Palo Verde Nuclear  
Generating Station

**Subject: Palo Verde Nuclear Generating Station (PVNGS)  
Units 1, 2, and 3  
Docket Nos. STN 50-528, 50-529, and 50-530  
Request for Amendment to Various Technical Specifications to  
Implement Administrative Changes**

### **Evaluation of the Proposed Change**

ACTIONS (continued)

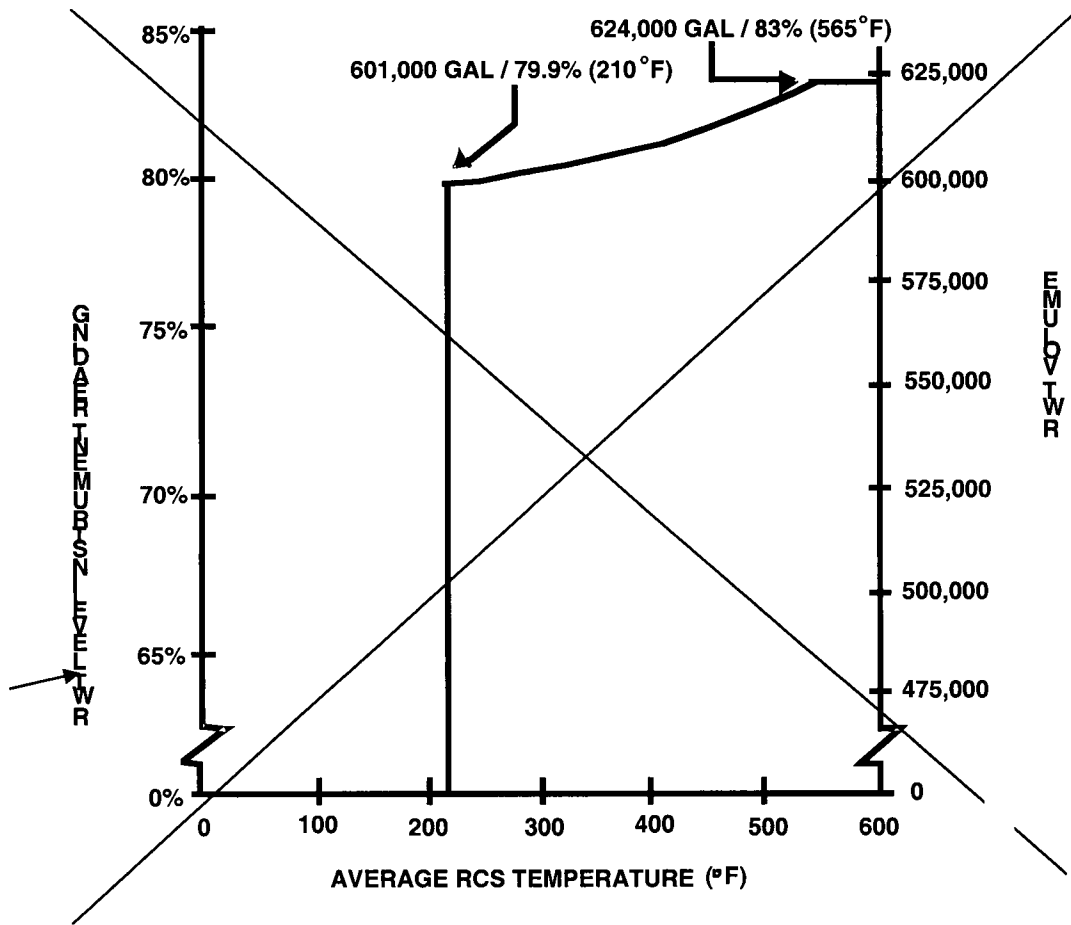
Revise the Required Actions A.1 and C.1 from “Place one CREFS train in operation,” to “Place one CREFS train in essential filtration mode.”

This revision is to clarify the Required Actions and to ensure complete understanding of the configuration necessary to meet those Actions. The change is a corrective action from the Unit 2 event described in LER 50-529/2011-001.

CONDITION	REQUIRED ACTION	COMPLETION TIME
C. CREFAS Manual Trip, Actuation Logic, or radiation monitor inoperable in MODE 5 or 6, or during movement of irradiated fuel assemblies.	C.1 Place one CREFS train in <u>essential filtration mode</u> operation.	Immediately
	<u>OR</u>	
	C.2.1 Suspend movement of irradiated fuel assemblies.	Immediately
	<u>AND</u>	
	C.2.2 Suspend positive reactivity additions.	Immediately
	<u>AND</u>	
	C.2.3 Suspend CORE ALTERATIONS.	Immediately

FIGURE 3.5.5-1  
Minimum Required RWT Volume

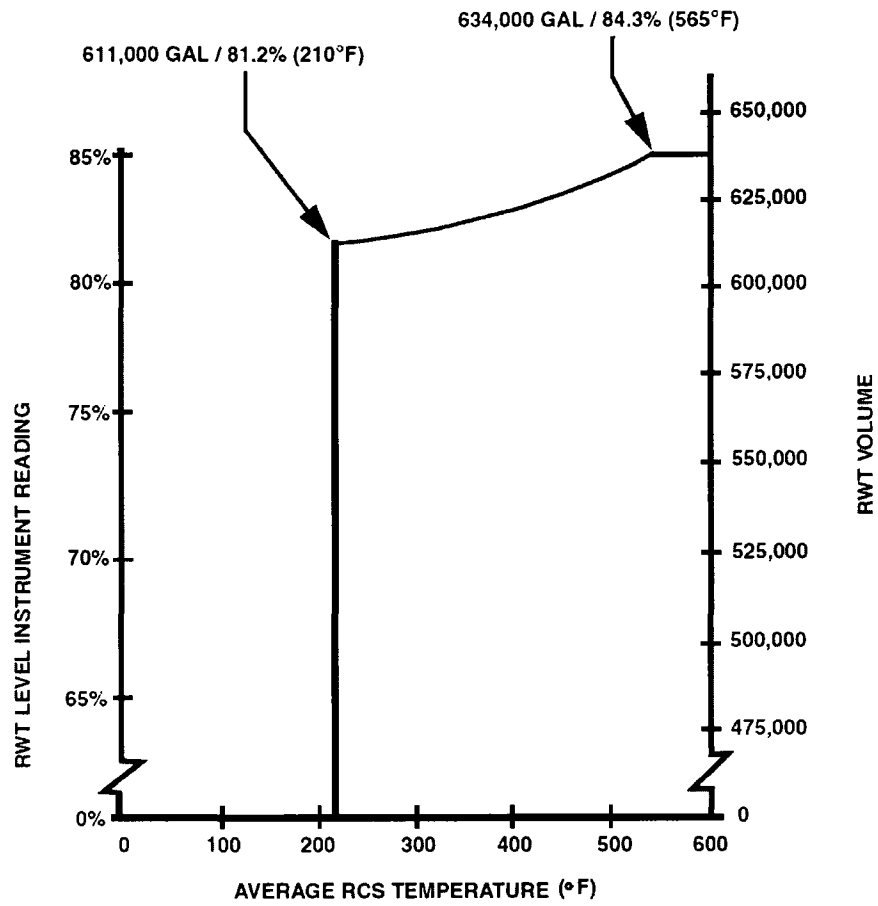
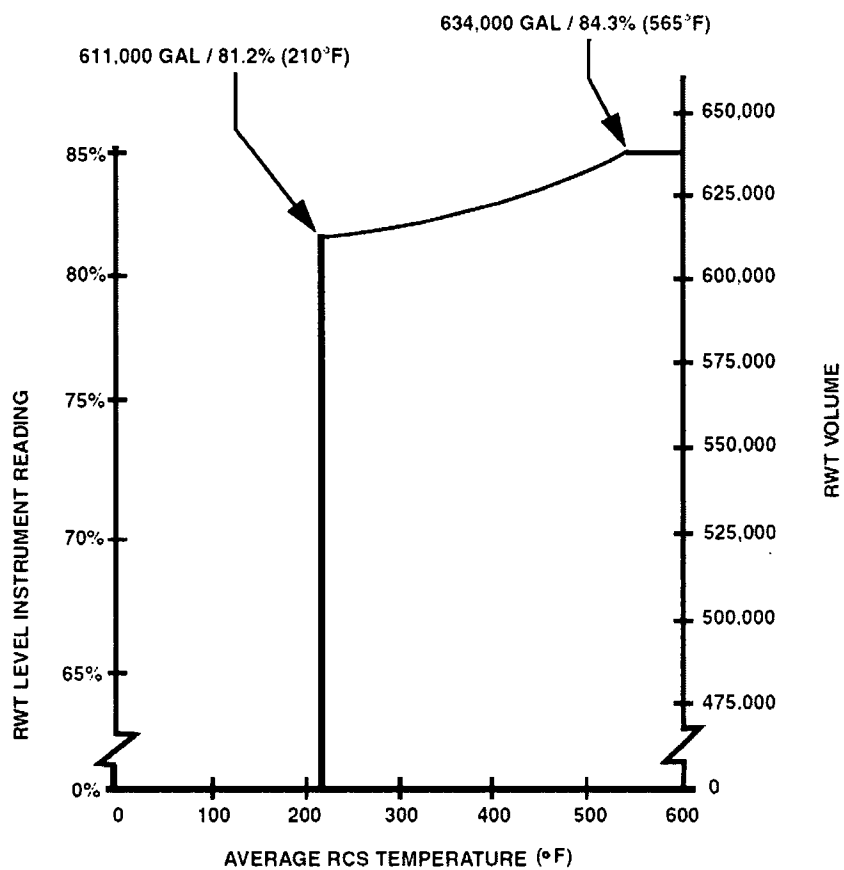
Delete the “Pre-RWT TS Setpoint Change” (page 3.5.5-3) version of Figure 3.5.5-1 Minimum Required RWT Volume and remove the words “After RWT TS Setpoint Change,” from remaining version of Figure 3.5.5-1 (page 3.3.5-4). This will include renumbering the remaining TS page.

As provided in approved License Amendment 182, the changes to the RWT level setpoints were to be implemented as the supporting modifications in each PVNGS units were completed. These modifications have been completed and the “After RWT TS Setpoint Change” minimum required RWT values are now fully implemented in Units 1, 2, and 3. As a result, the “Pre-RWT TS Setpoint Change” version of the figure is no longer needed and can be removed.

DELETE  
THIS  
FIGURE  
AND  
PAGE

~~FIGURE 3.5.5-1~~  
Minimum Required RWT Volume

FIGURE 3.5.5-1  
Minimum Required RWT Volume
